To: Members of Dublin City Council
From: Marsha I. Grigsby, City Manager 
Date: March 7, 2013
Initiated By: Steve Langworthy, Director of Land Use and Long Range Planning
Re: Ordinance 22-13 - Rezoning approximately 28.1 acres on the west side of Hyland-Croy Road, approximately 1,030 feet north of the intersection with Brand Road and Mitchell-Dewitt Road, R, Rural District to PUD, Planned Unit Development District to establish a 44 lot single-family detached residential development and 8.75 acres of open space. (Case 12-082 Z/PDP/PP) (Celtic Crossing PUD)

Ordinance 22-13 is a request for review and approval of a Rezoning with Preliminary Development Plan from R, Rural District to Planned Unit Development District (Celtic Crossing PUD), and a Preliminary Plat for 28.1 acres to establish a 44 lot single-family detached residential development with 8.75 acres of open space.

12-082 Z/PDP/PP
 Rezoning/Preliminary Development Plan/
 Preliminary Plat
 Celtic Crossing
 Hyland Croy Road

**CONCEPTUAL
 LANDSCAPE PLAN**

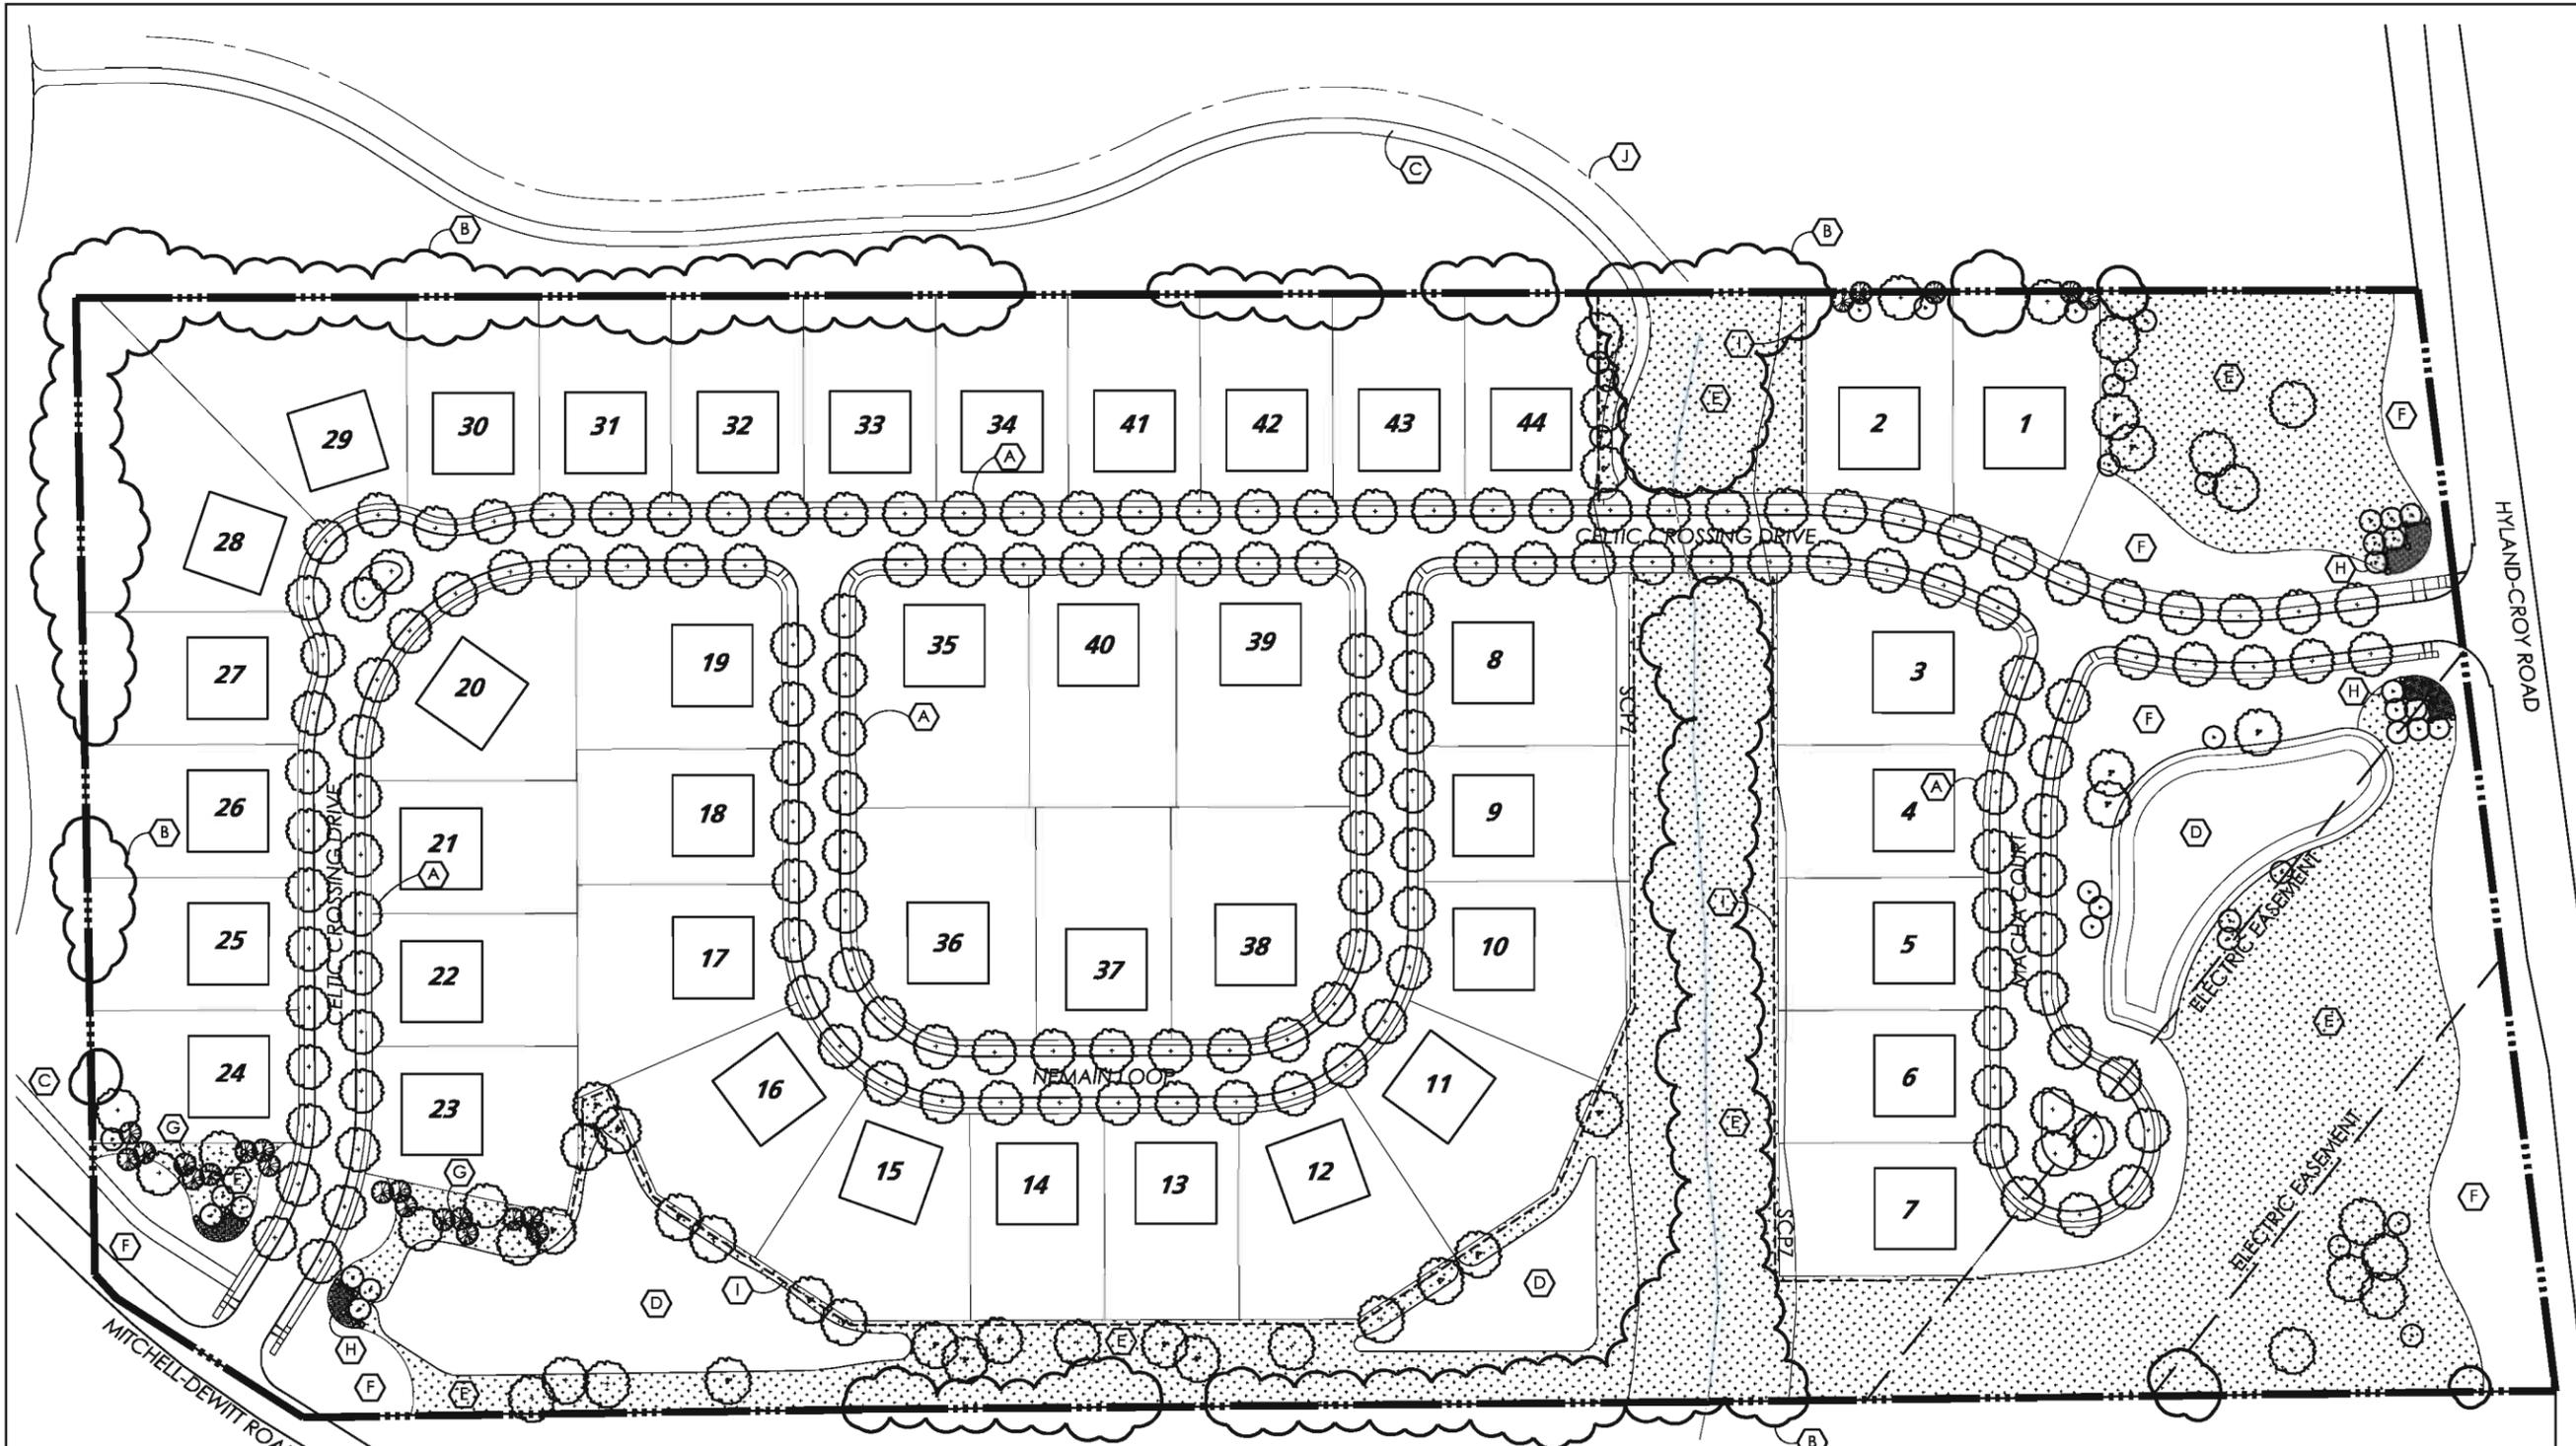
- 4) That gaps in the existing tree row along the rear of Lots 1 and 2 be augmented with additional trees/and or other landscape materials as part of the final development plan;

CITY OF DUBLIN, UNION COUNTY, OHIO
 PRELIMINARY DEVELOPMENT PLAN
 FOR
CELTIC CROSSING
 PRELIMINARY PLAT

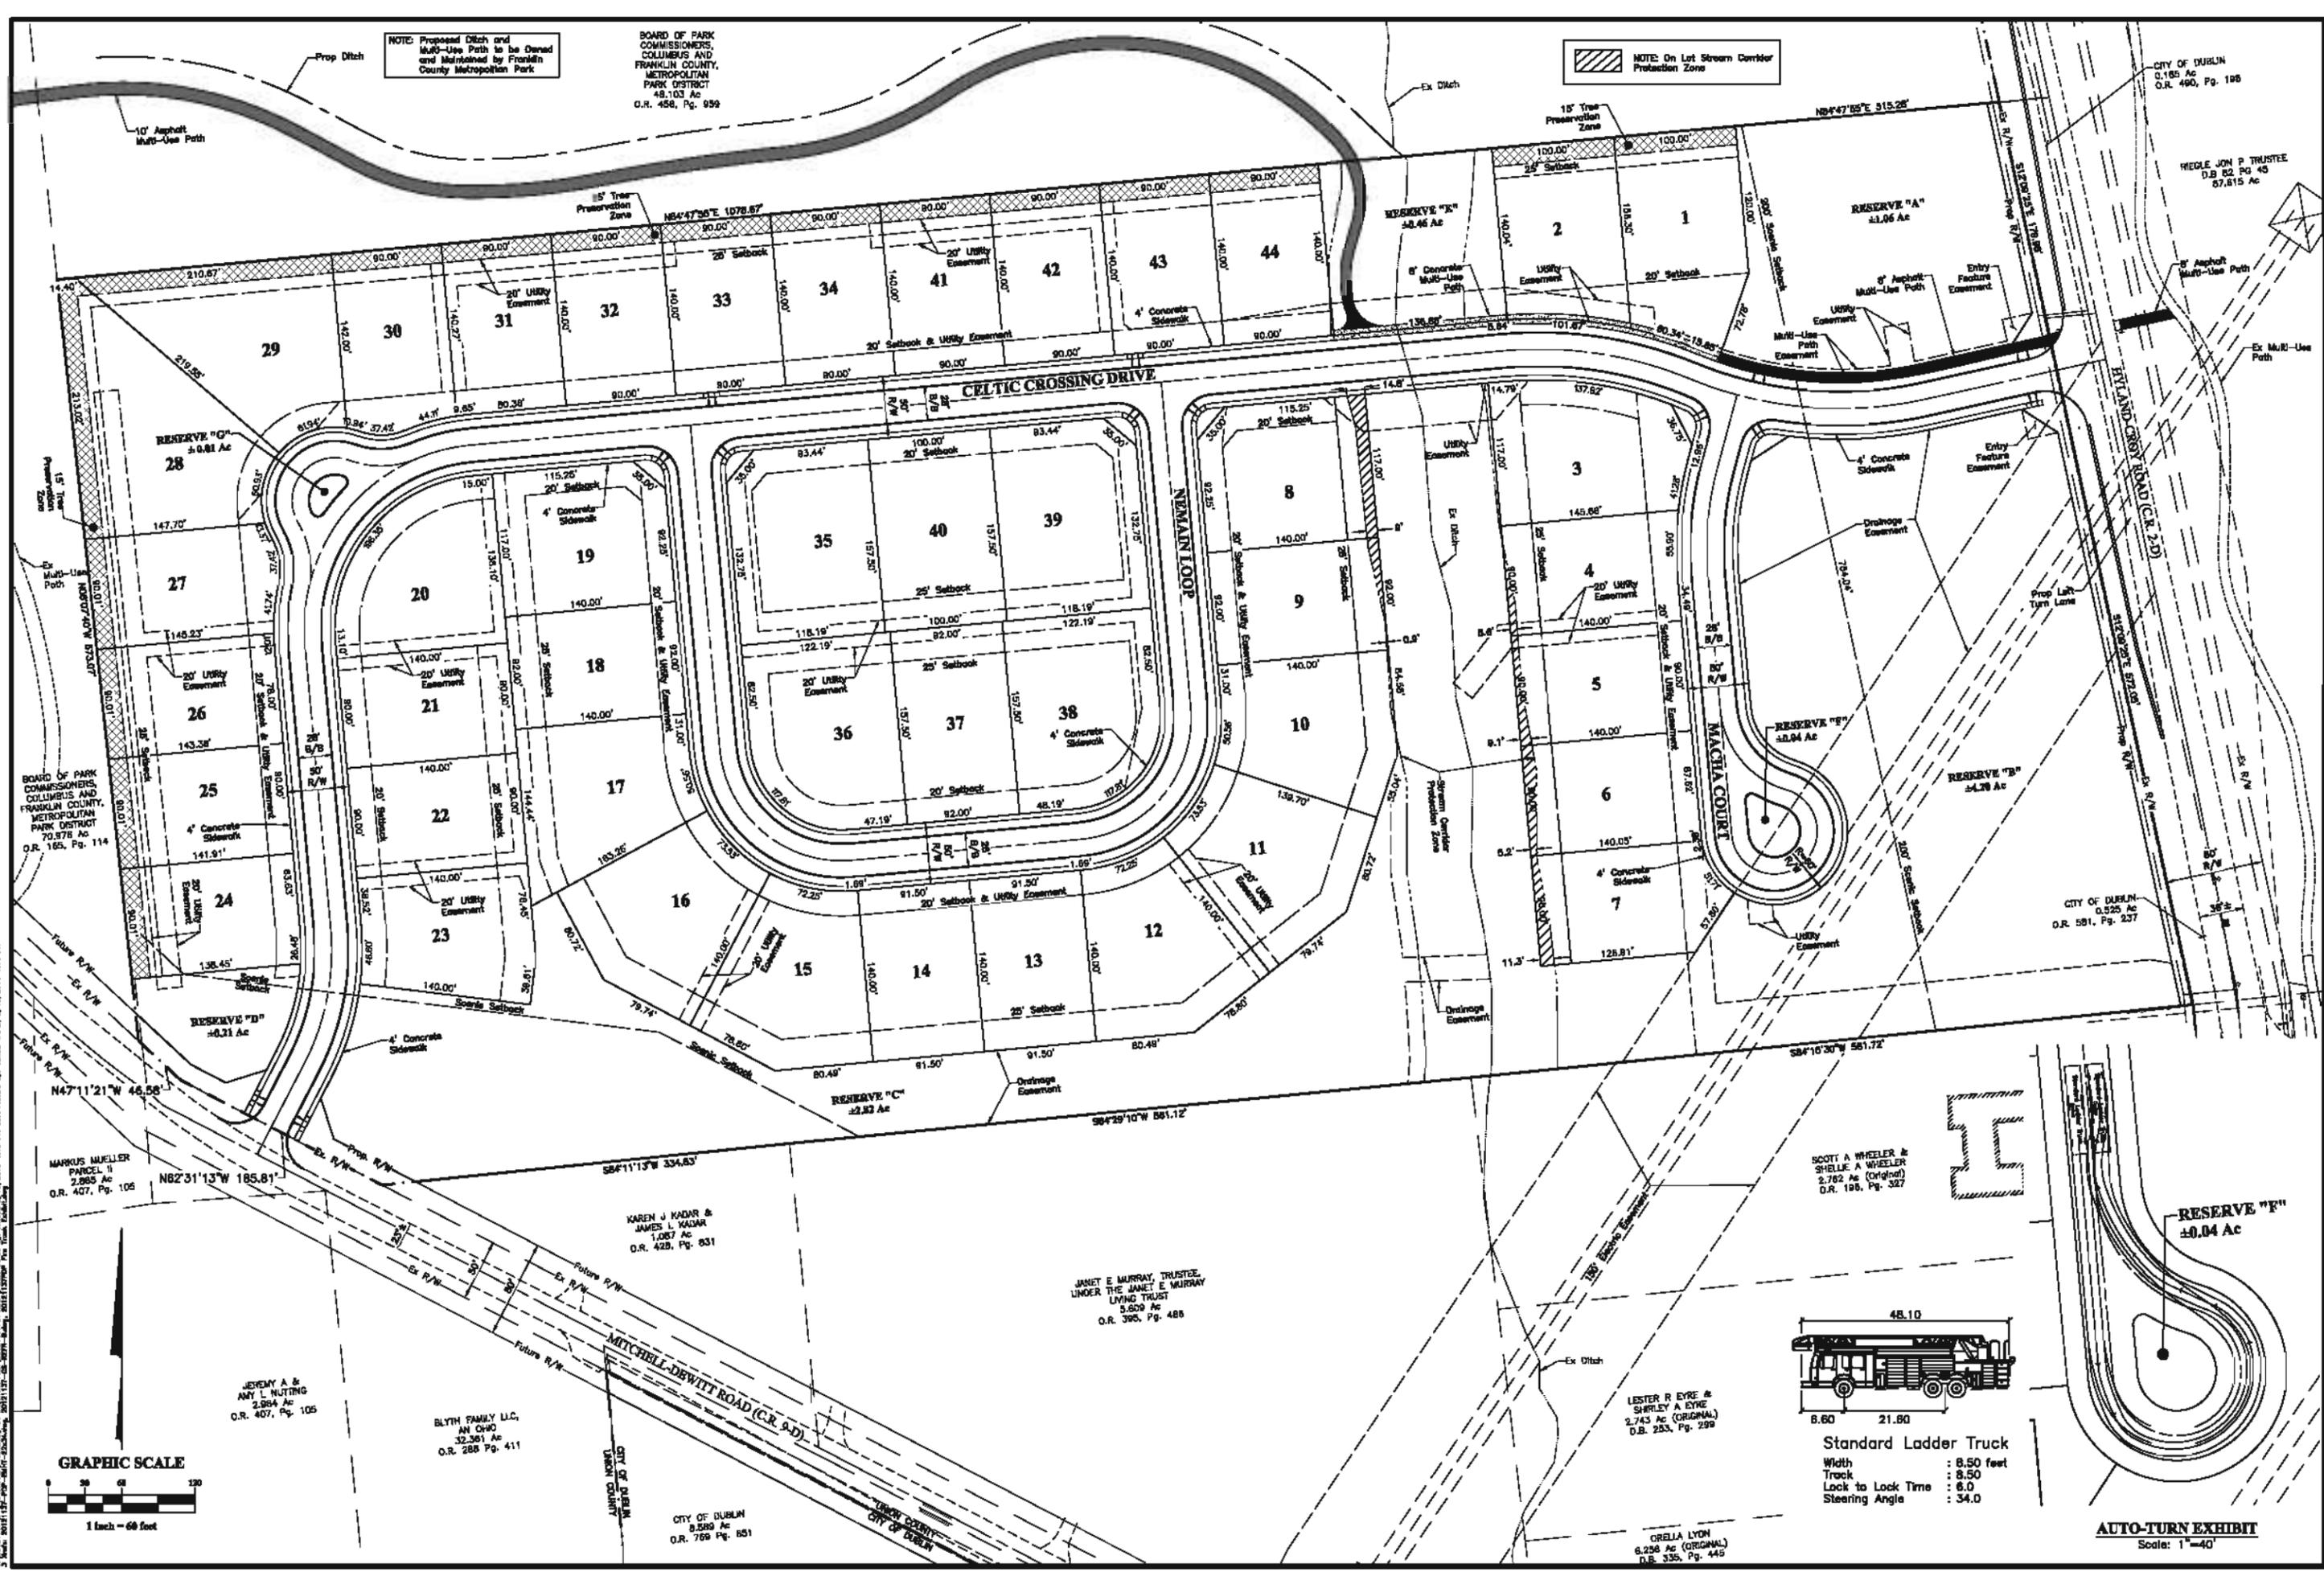
Ms. Kramb noted that the Preliminary Plat did not have the path shown on the Mitchell-DeWitt Road side, but said she knew that they were still working with the Metro Parks to develop it. She asked if a revised Plat would be necessary to show the path.

Ms. Kramb asked where the offsite swale mentioned in the Planning Report was shown on the plat.

Ms. Kramb pointed out a typographical error in the preliminary plat condition written in the Planning Report.

Mr. Goodwin said that Planning would also like to modify the preliminary plat condition to include the proposed out loop as a platted reserve as well.

- 1) That the preliminary plat be revised to identify the Macha Court cul-de-sac island and the Celtic Crossing Drive 'eyebrow' loop island as platted reserves prior to submission for City Council review.

Mr. Goodwin said if they received approval from Metro Parks to make the path connection, they would continue to show it on the final development plan as shown on the preliminary development plan and it would be included on the final plat. He said explained that the path connection is not being required, but Planning is asking that the applicant make their best effort to seek Metro Parks' approval.
